SERVICE BULLETIN

TITLE: PROPELLERS - LEFT ENGINE PROPELLER UNFEATHERING ACCUMULATOR OIL TUBE ASSEMBLY CHAFING INSPECTION AND MODIFICATION

BEECHCRAFT Model 58 and G58 Baron, Serials TH-2097 through TH-2150 with optional propeller unfeathering accumulators installed.

Figure 1

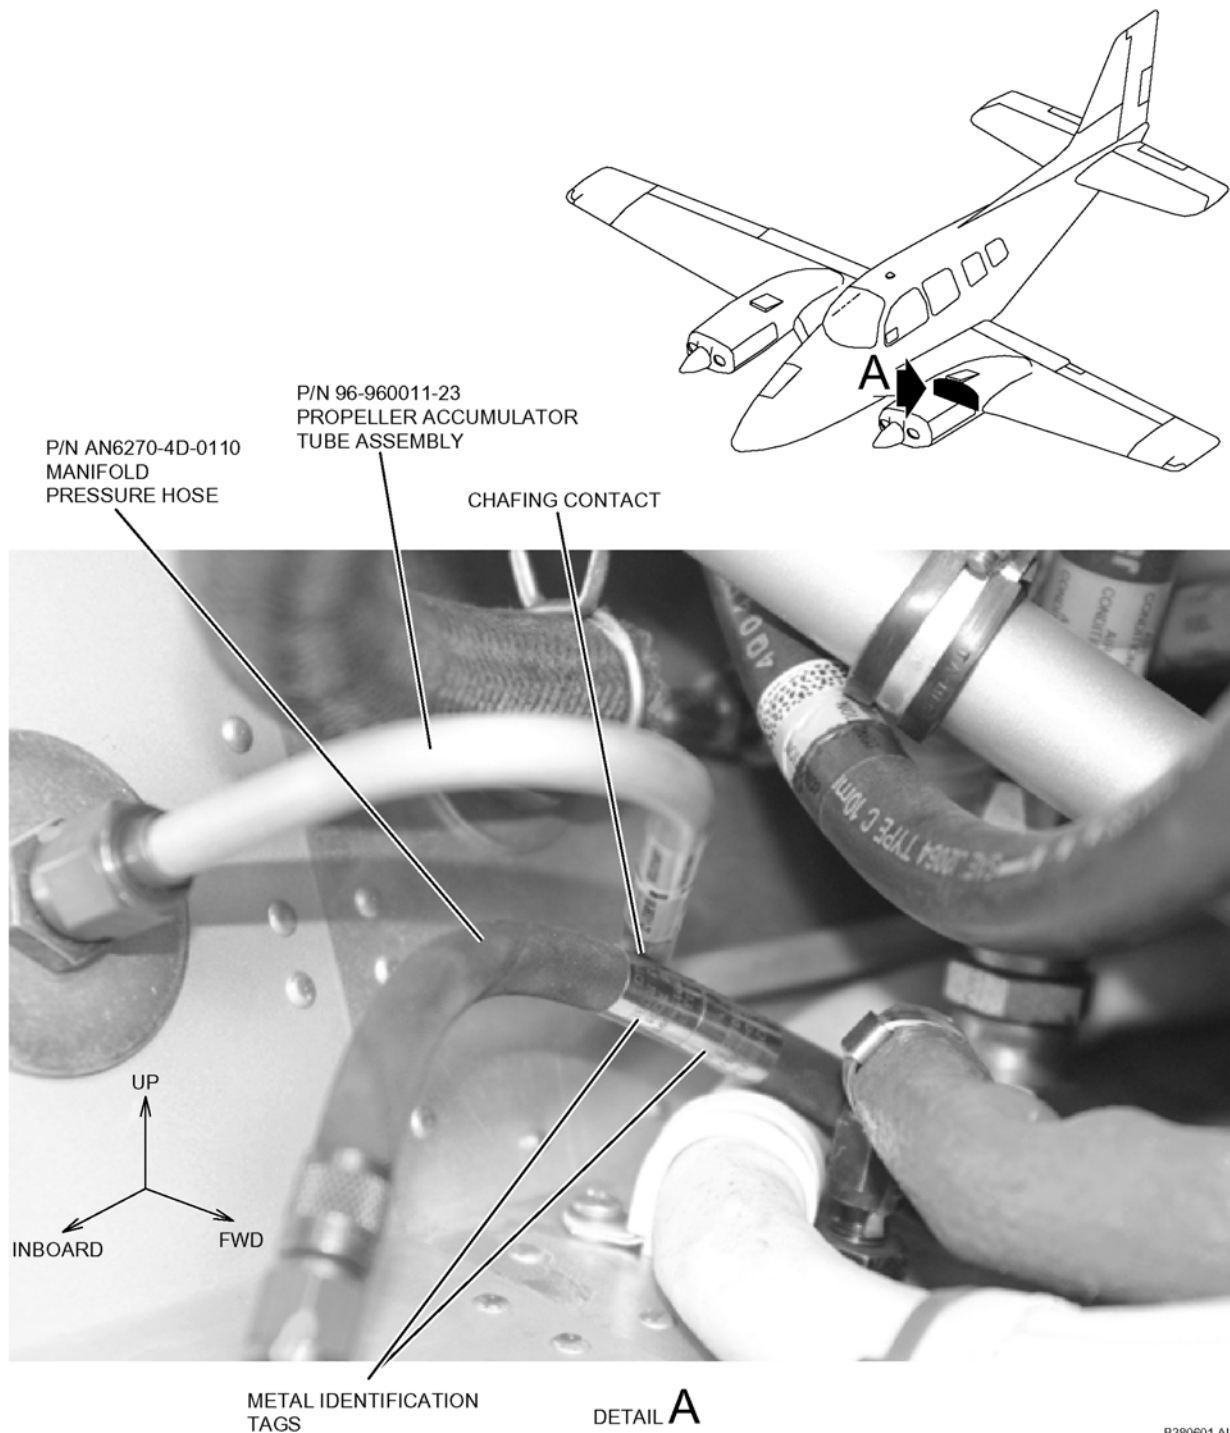
- (2) Inspect the engine manifold pressure hose and its metal identification tags for proper routing and adequate clearance to avoid any chafing with the propeller accumulator tube assembly. Refer to Figure 1.

- (3) Inspect the propeller accumulator oil tube assembly for chafing damage, paying particular attention to the area identified in Figure 1. If any chafing damage is present, the tube must be replaced before further flight. Reference Section 1 of the BEEHCRAFT Baron 55/58 Shop Manual for torque of applicable fittings.

Figure 2

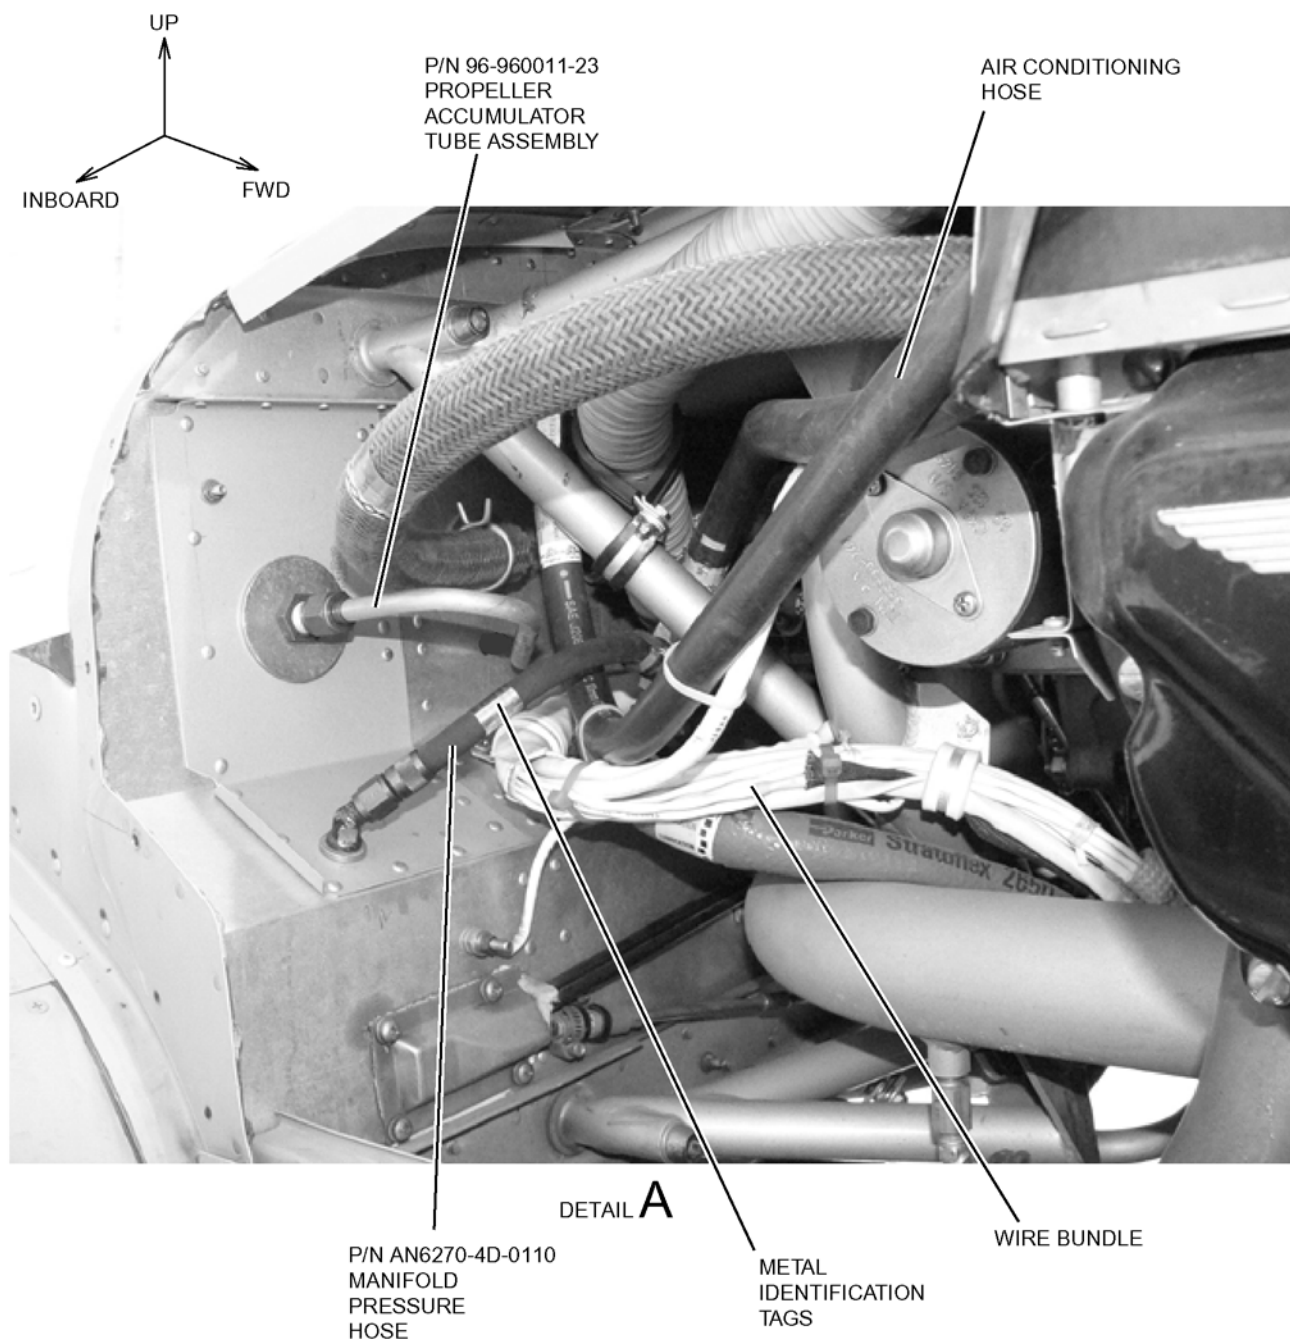
- (4) Position (relocate) and secure both the manifold pressure hose and its metal identification tags to avoid contact with other tubes, hoses, electrical wires, parts, components and structure. Refer to Figures 2 and 3 and proceed as follows:

- (a) Disconnect the manifold pressure hose at the firewall fitting and route it above the wire bundle and air conditioning hose. Refer to Figures 2 and 3.

- (c) Attach an MS21919WDG8 clamp to the manifold pressure hose (1/2 inch) and an MS21919WDG10 clamp to the engine mount assembly (5/8 inch). Position clamp on engine mount to achieve maximum clearance with surrounding components and structure. Secure the manifold pressure hose to the engine mount assembly as shown in Figures 2 and 3. Secure the clamps together with an AN3-4A (NASM3-4A) bolt, AN960-10 (NAS1149F0363P) washer, and an MS21042-3 (NASM21042-3) self-locking nut.
